Access Compliance Report

Public Rights-of-Way

(Curb Ramps)

Intersection ID: 47915	Main Street: ROOK_RD	Cross Street: OAKDALE_RD	Location: SW
ADA ID: 64246088B65C	Ramp Type: Perp	Initial Pass/Fail: Fail	Overall Compliance: No
Severity Score: 13.75			
Codes/Mitigation Info/Possible Solution		Field Measurements/Component Compliance

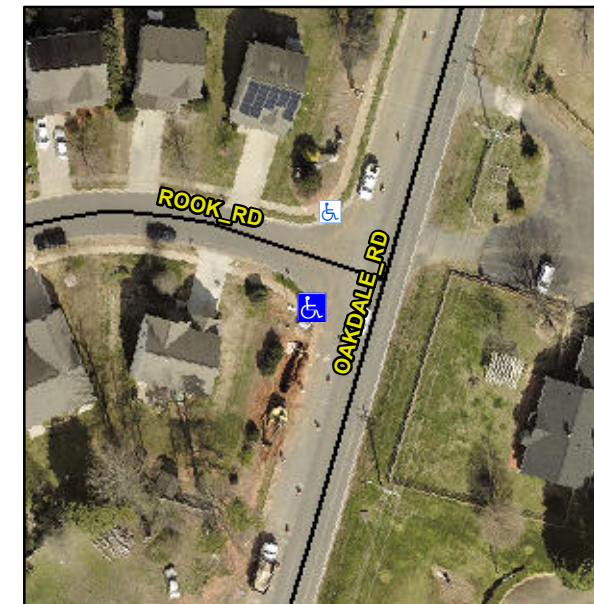
R304.2.2, R304.5.3

Compliance	Description	Data	Compliance	Description	Data
N/A	Ramp Length (in)	49.0	No	Ramp Slope (%)	11.1
Yes	Ramp Width (in)	48.0	No	Ramp XSlope (%)	3.5
N/A	Flare Type LT	N/A	N/A	Flare Type RT	N/A
N/A	Flare Slope LT (%)	N/A	N/A	Flare Slope RT (%)	N/A
N/A	Flare Traversable LT?	N/A	N/A	Flare Traversable RT?	N/A
N/A	Landing Length (in)	N/A	N/A	DWS Provided?	N/A
N/A	Landing Width (in)	N/A	N/A	DWS Contrast?	N/A
N/A	Landing Slope (%)	N/A	N/A	DWS Length (in)	N/A
N/A	Landing X Slope (%)	N/A	N/A	DWS Full Width?	N/A
N/A	Landing Curb? (Y/N)	N/A	N/A	DWS Offset (in)	N/A
N/A	Shared Landing?	N/A			
N/A	Gutter Ponding?	N/A	N/A	Gutter Slope (%)	N/A
N/A	Gutter Lip Ht (in)	N/A	N/A	Gutter X Slope (%)	N/A
N/A	Painted X Walk1?	No	N/A	Painted X Walk2?	N/A
	X Walk 1 Direction	To NE		X Walk 2 Direction	N/A
N/A	X Walk 1 Width (in)	N/A	N/A	X Walk 2 Width (in)	N/A
	X Walk 1 Slope (%)	0.0		X Walk 2 Slope (%)	N/A
	X Walk 1 X Slope (%)	0.5		X Walk 2 X Slope (%)	N/A

Remove & Replace Entire Ramp.
